DNARD Rev. 5.0 Video Rework

15 June 1998

This notice is for the Digital Network Computer Reference Design, Revision 5. It provides rework instructions for the video controller circuit to minimize certain image instability problems that can be observed on the monitor. The rework involves removing one resistor and relocating three discrete components (that are already on the board) so that these problems are eliminated.

Schematic: (Click on schematic for full-size version in Adobe PDF format)

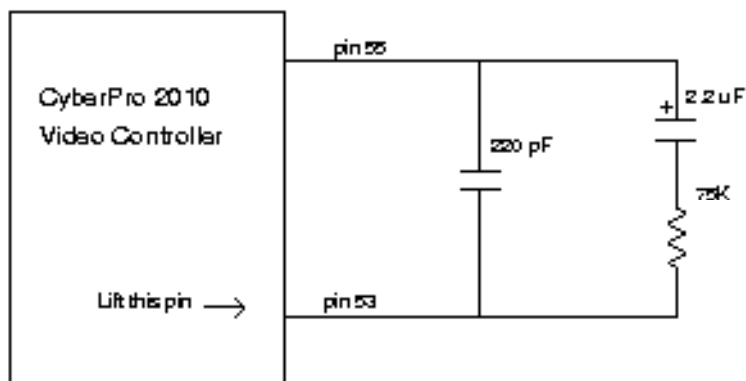
The rework involves removing one resistor and adding three discrete components.

Note: A photograph of the ideal rework implementation is included below for reference, as well as a schematic showing the changes.

Removed resistor

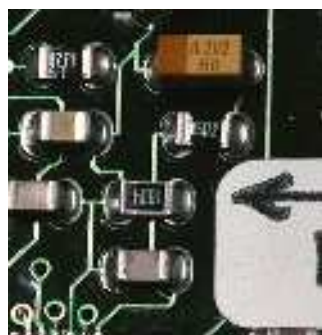
1. Remove the 1 Megohm surface mount resistor indicated in the left photograph.
2. Unsolder and lift pin 53 (a corner pin) of the CyberPro 2010 graphics chip from the pc board. See center and right photographs below.
3. Add the three components listed in the Bill of Materials above. Arrange them as shown in the center and right photographs. They are to be connected between the lifted pin 53 and pin 55 of the graphics chip. The components should be positioned as close to the edge of the chip as is shown. The positive end of the 2.2uF capacitor connects to pin 55.
4. Carefully inspect pins 53 through 55 of the graphics chip for good solder joints and verify that there are no shorts.
5. Apply the firmware patch described in the [instructions](#) provided.
